Product Change Notice (PCN)

PCN Number: **PCN-0750176R-01**

Product(s) Affected: **CUSA-TR09-02-1000-TH67**

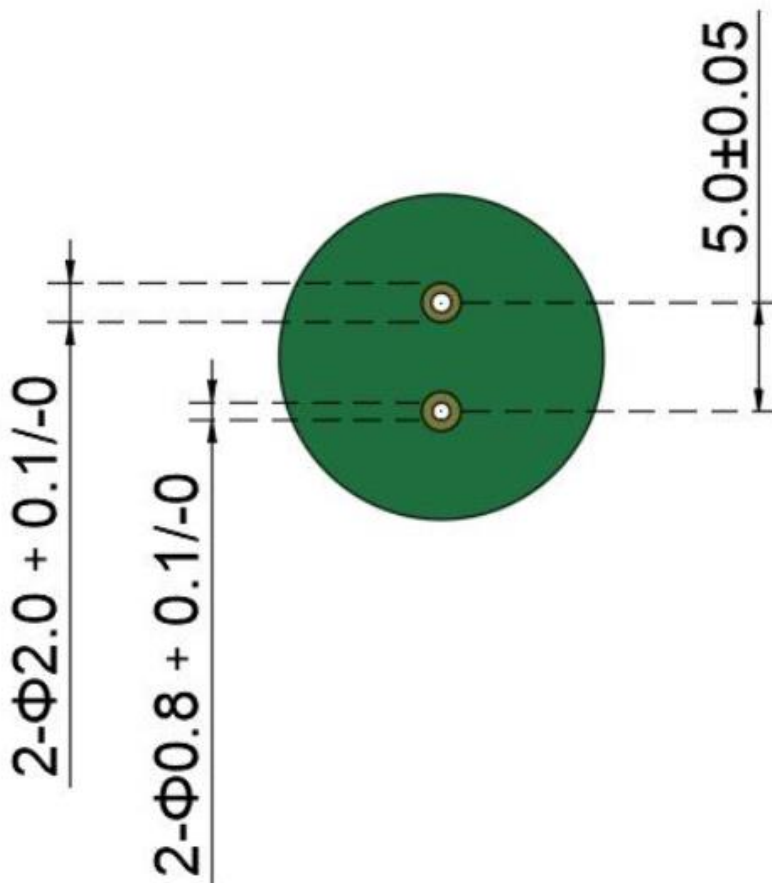
Description of Change: **Capacitance changing from 600pF to 400pF. PCB footprint drawing updated to include more specified dimensions, as shown below:**
